PLANNING & ZONING COMMISSION
Town of Canaan (Falls Village)
Public Hearing & Regular Meeting Minutes August 27, 2026
108 Main Street, Falls Village, CT
In-person and via Zoom

A. Re-subdivision of Music Mountain Farm — Lots 4A and 11A

Music Mountain Farm Lots (Aspen Hill Drive) — Re-Subdivision— Project Narrative and Design

RE-SUBDIVISION PLAN
MUSIC MOUNTAIN FARM LOTS 118, 119 AND 120
ASPEN HILL DRIVE - CANAAN - Map 7 Lot 40846

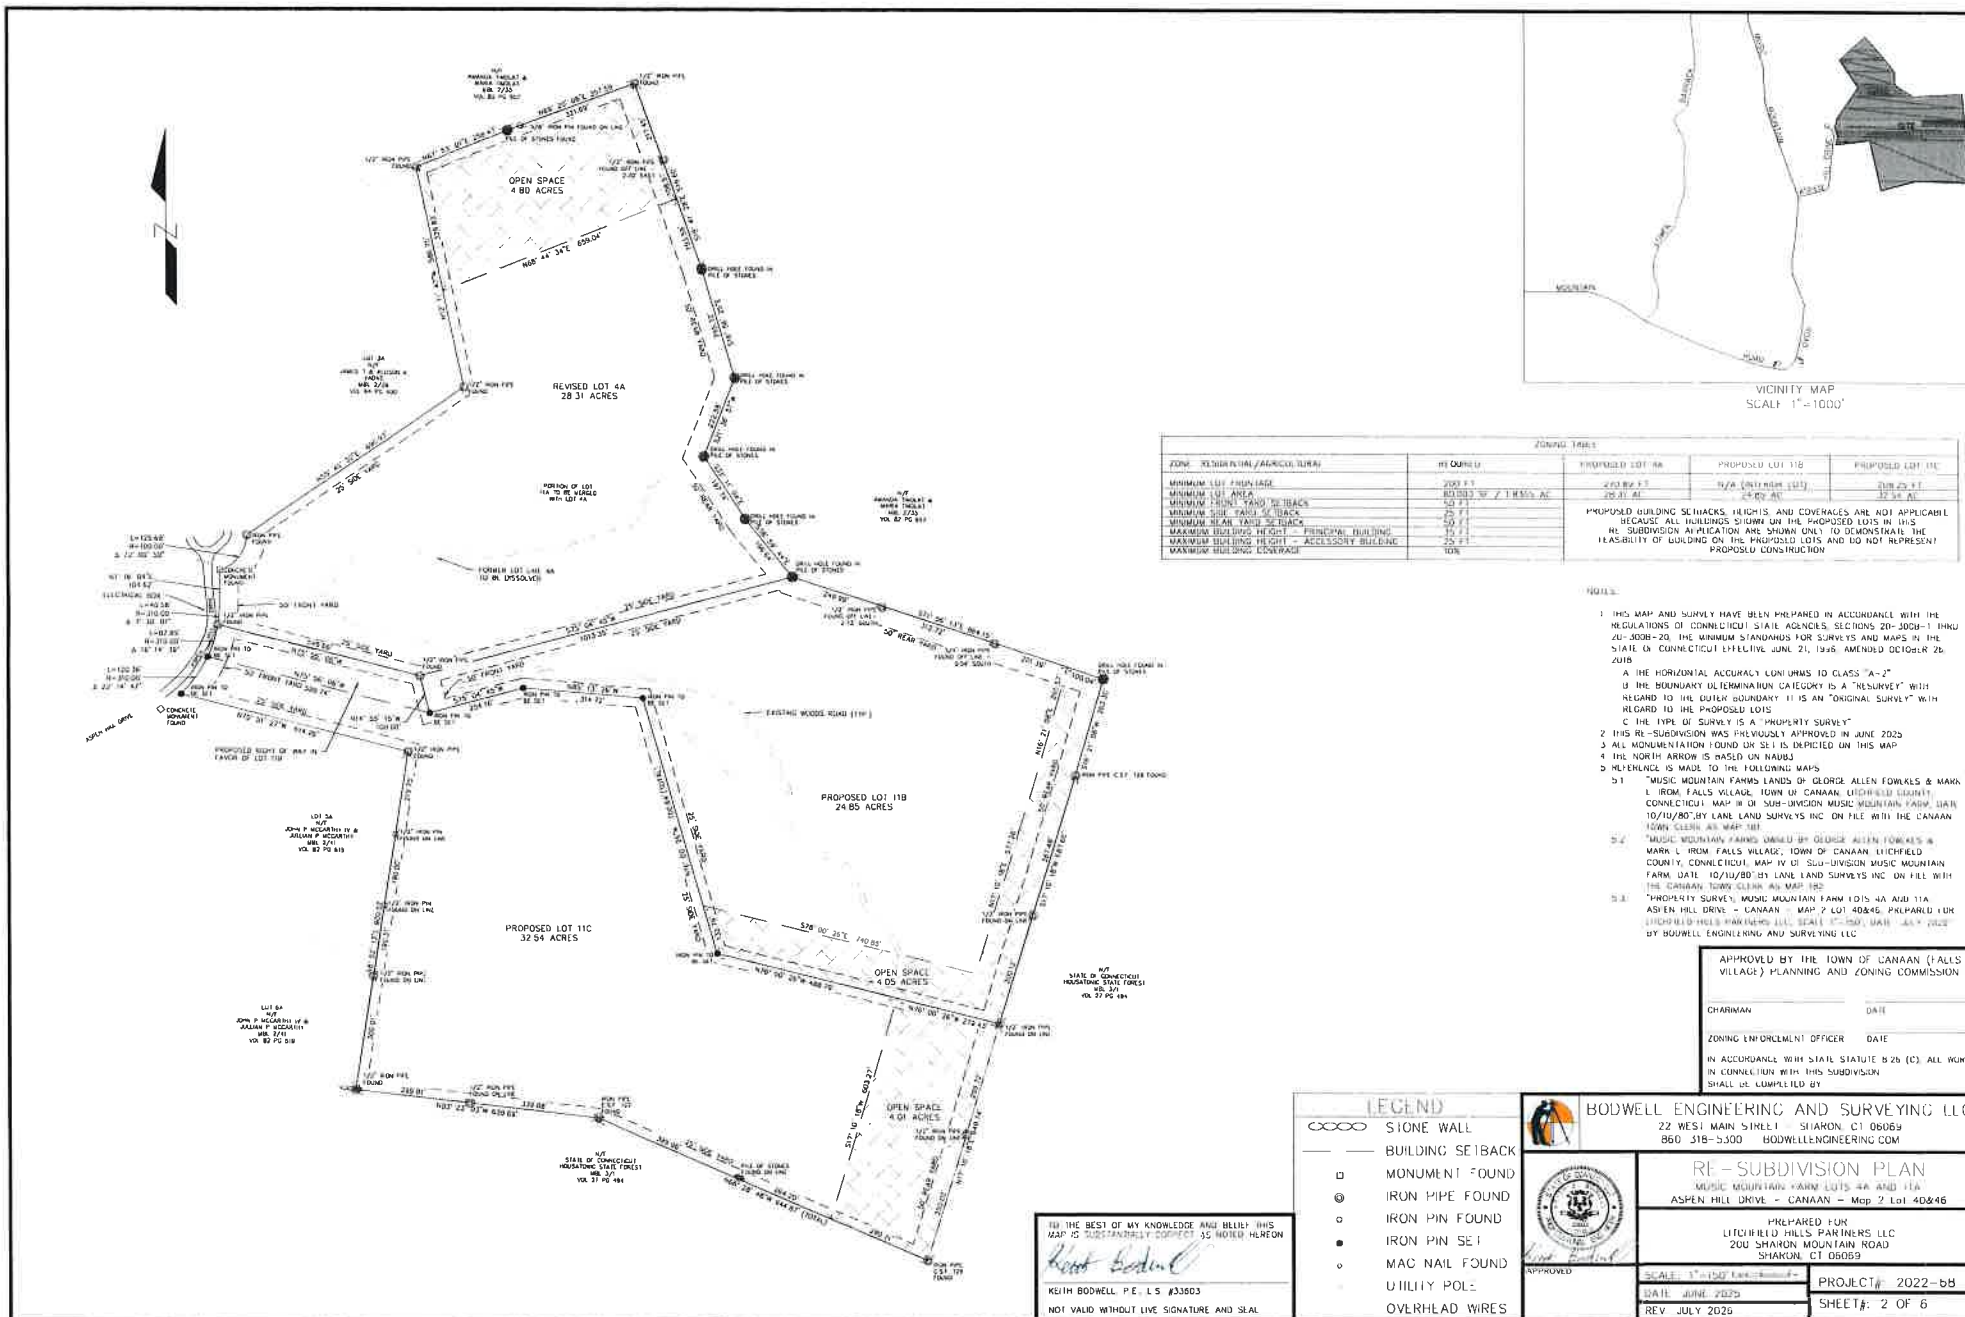
Open Space: 15.01% total (4.8 acres, 4.05 acres, 4.01 acres). **Survey:** A-2 Survey Map.

- **Drawing Scale:** Applicant requested 1" = 150 ft instead of 1" = 40 ft.
- **Index Map:** Not needed due to single-sheet submission.
- **Tree Identification:** Applicant requested waiver; Commission discussed requiring tree caliper identification at site plan stage.
- **Road Design:** Not applicable (no public road).
- **Drainage Design:** Conceptual only; full design required at site plan.
- **Utility Design:** Deferred until development; full design required at site plan.
- **Construction Details:** Conceptual only; full details required at site plan.

SITE PLAN
MUSIC MOUNTAIN FARM LOTS 4A AND 11A
ASPEN HILL DRIVE, CANAAN, CT Map 2 Lot 40&46

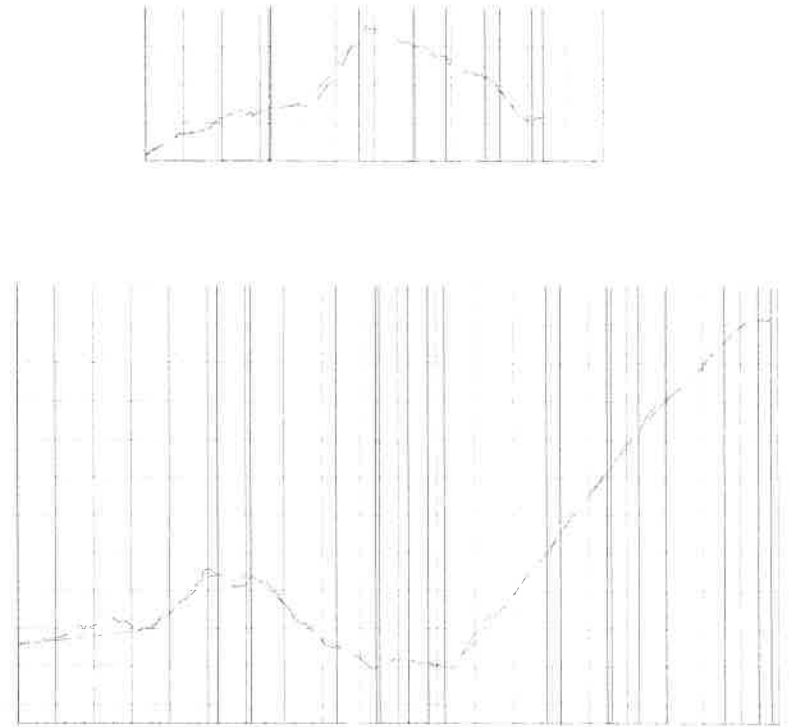
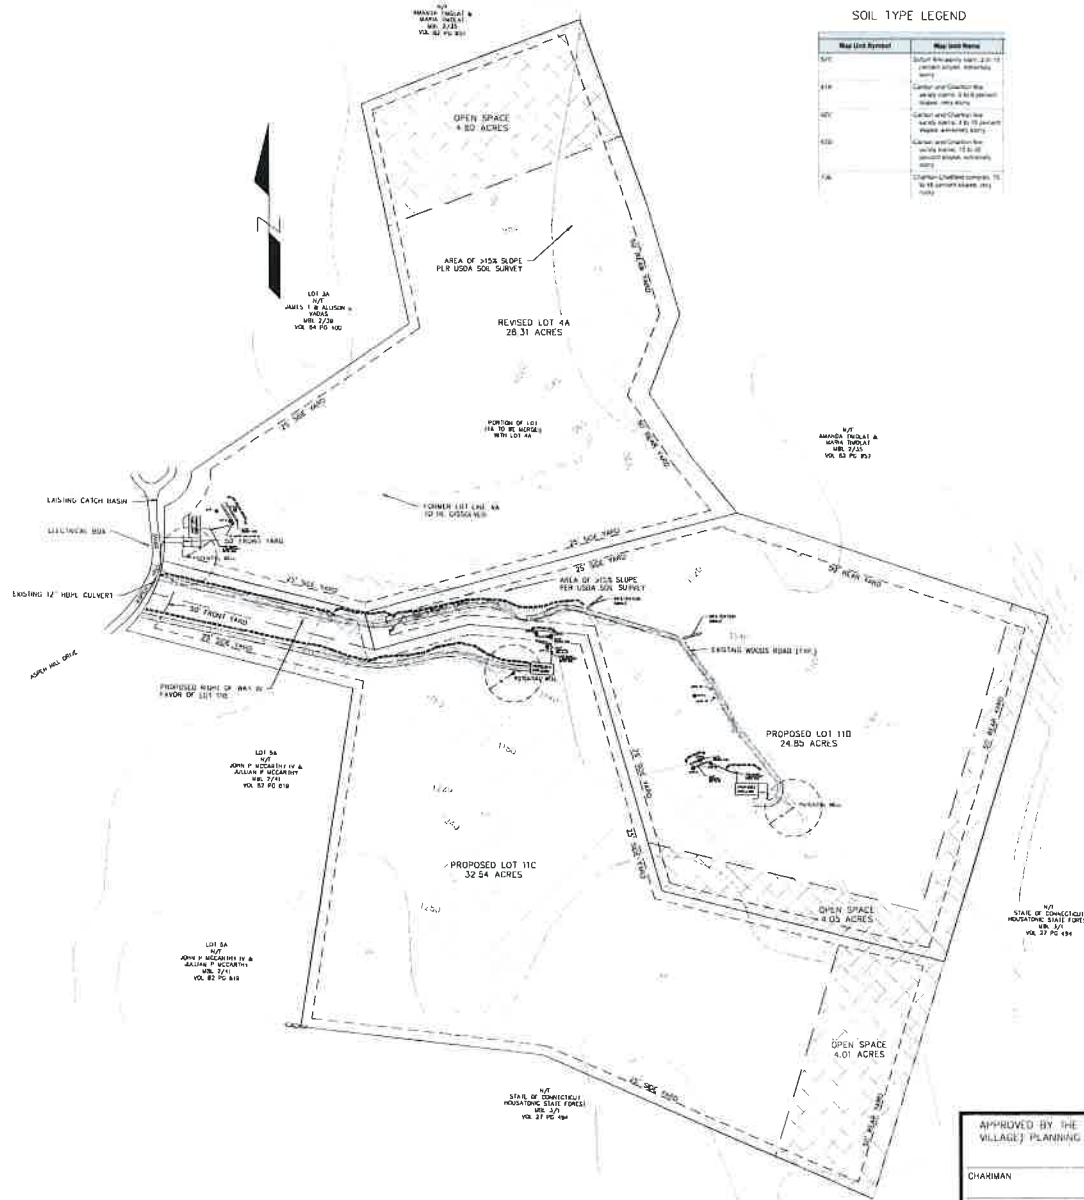
Topography: PDF topo lines did not render correctly; applicant will correct on final Mylar.

Stormwater: Soils are well-drained sandy loams; swales recommended. Commission emphasized lot-specific stormwater plans.

Topography Correction: Full topographic map must be corrected on final Mylar.
